Officers' Meadow Masterplan

Officer's Meadow, Shenfield Pre-Application Scoping Note

Our Reference: 23/06046/PMAJ

Erection of 344 dwellings (including 121 affordable dwellings) accessed from Chelmsford Road and Alexander Lane, as well as a new primary school, with associated highway works, landscaping, utilities, drainage, infrastructure, and parking | Land at Chelmsford Road, Shenfield, Brentwood

Project:
OFFICERS' MEADOW
SHENFIELD
Client:
CROUDACE HOMES
Drawing:
PROPOSED SITE LAYOUT
BLOCK PLAN
Drawing no: 1643.100
Rev: P

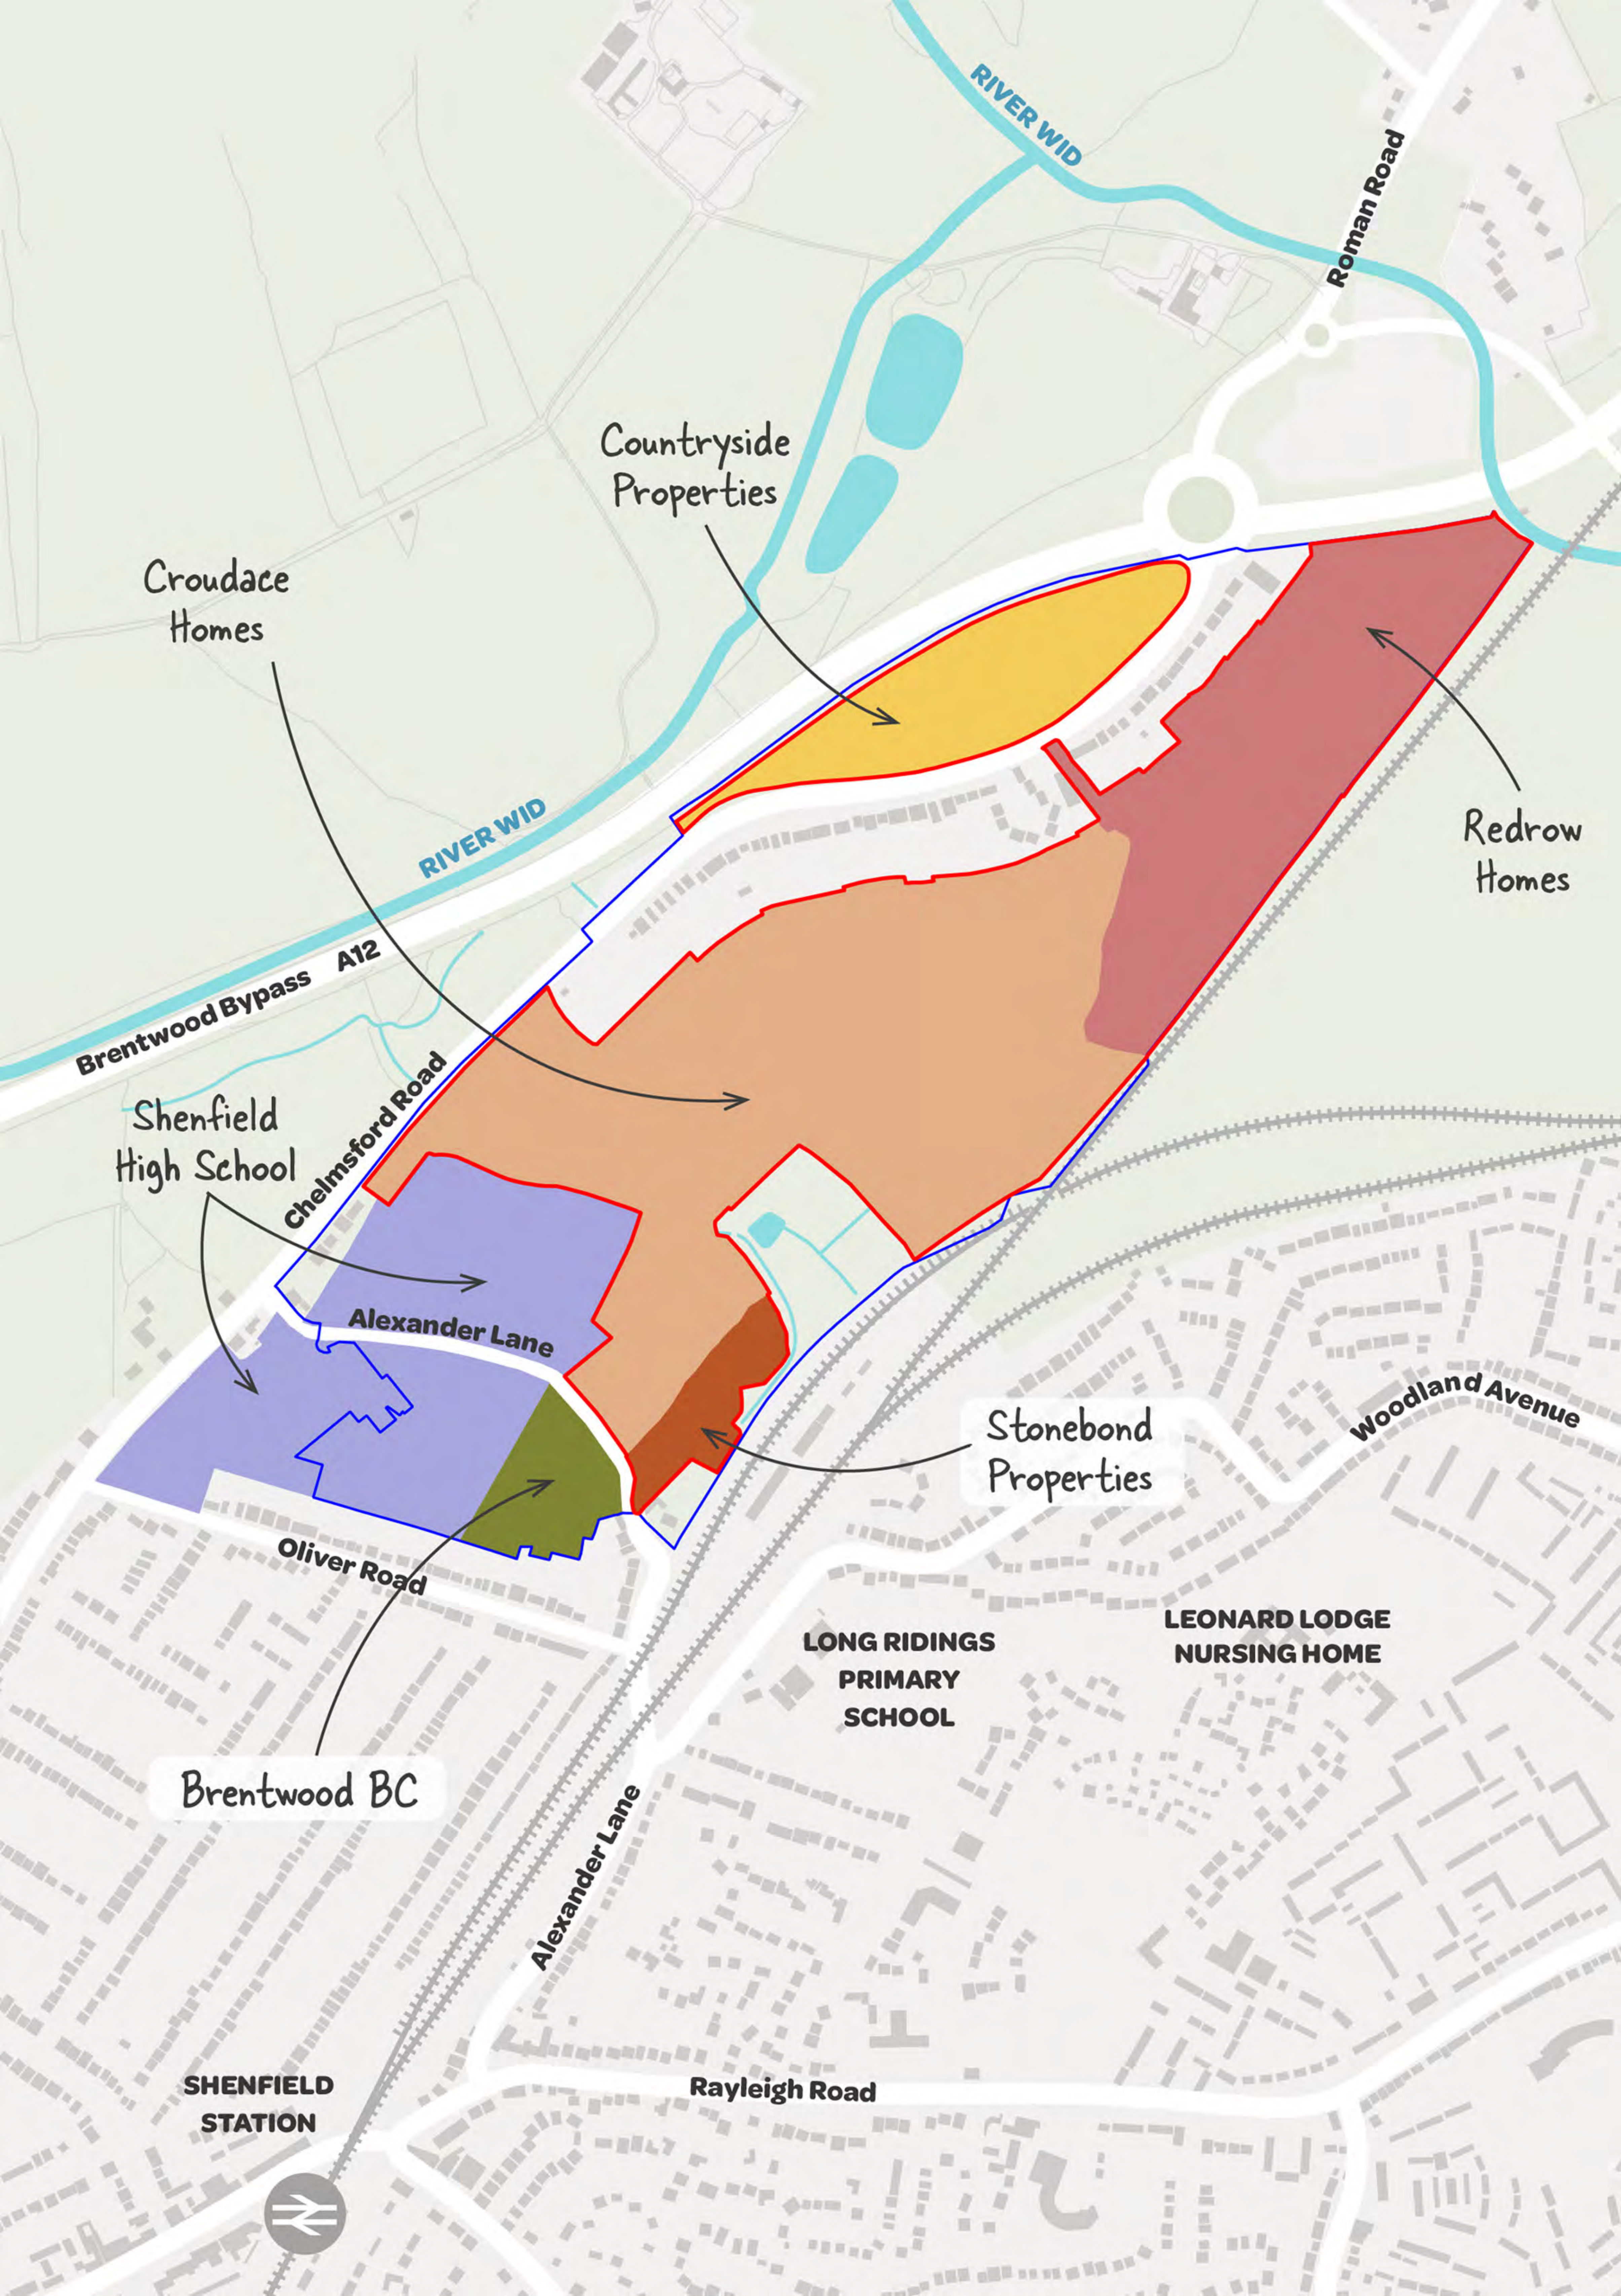
4.22 Units 223-285 are now articulated into three groups by incorporating footpaths. This improves the permeability of the site and is welcomed by officers.

4.23 There are circa 20 detached dwellings in the southern part of the site. Officers feel there is an opportunity to increase the number of terraced houses at this location, which would help in achieving a higher density and a more attractive townscape. Officers advise Croudace to consider changing Units 335-338 or Units 288-291 to terrace houses with parking spaces positioned on the side.

4.24 The western gateway now comprises an L-shaped apartment building and a row of terraced houses. The car park is positioned at the rear of the building. This is a successful layout and is supported by officers. Officers would also encourage Croudace to introduce more landscape features at this location.

4.25 The vehicle route that cut through the TPO tree line in the previous layout has been removed, and a new pedestrian and cycle link is proposed in lieu. This is welcomed by officers, as it improves accessibility to the landscape feature and ensures it full protection preventing it being severed.

4.26 There are new pedestrian links proposed from the shared surfaces (near Units 239 and 211) to the LEAP. Additionally, the LEAP is connected to the Public Right of Way via a new proposed pedestrian link. These revisions are welcomed as they improve the permeability and accessibility of the public open space.

4.28 We encourage Croudace to consider incorporating more pedestrian links across the site at various landscaped areas or public open spaces. For example, new links could be proposed to the south of apartment units 34-70.

4.30 Although both Croudace and Stonebond have confirmed that this link could not be delivered, officers request that further consideration is given to it. A connection could be achieved between unit 330 (Croudace) and units 43-45 (Stonebond). The link could take the form of a footpath, which would be privately managed, as many aspects of the development are expected to be. No residential units would be lost as a result of the footpath, yet it would provide a connection through the two parcels closer to the Alexandra Lane entrance. The Council's Tree Officer has confirmed that a replacement tree would be acceptable in this location, if required and subject to details.

- 4.49 The frontage parking in the previous layout, (near Units 79-95 and Units 260-280) has been removed. This reduces the presence of vehicles on the streetscape, and is welcomed by officers.

- 4.53 There are 9 visitor parking spaces (V35, V36, V40, V41, V48, V49, V50, V51, V56) close to the vertical tree line to the north-east of the site, with no nearby footpath. Officers consider that this area is still car-dominated and request that these car parking spaces are relocated, and that a pedestrian footpath is provided along the vehicle route to the east of the tree line.
